#### Porthole Alley Redevelopment

Adopt a Resolution, transmitting comments to the Applicant
regarding the proposed development (*R-X*)

UNC Development Plan

# Urban Design Comments

### **Downtown Focus Area**

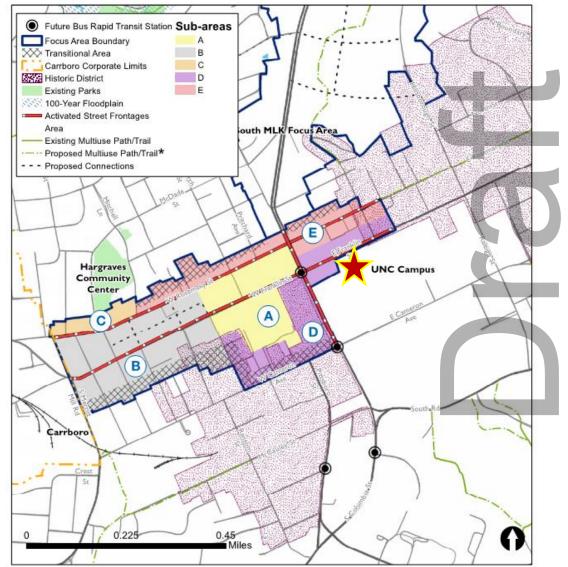
- Site is adjacent to but not in Downtown Focus Area
- Consideration given to:
  - Public entrances
  - Vibrant pedestrian zones
  - Public art opportunities
  - Wide pedestrian zones
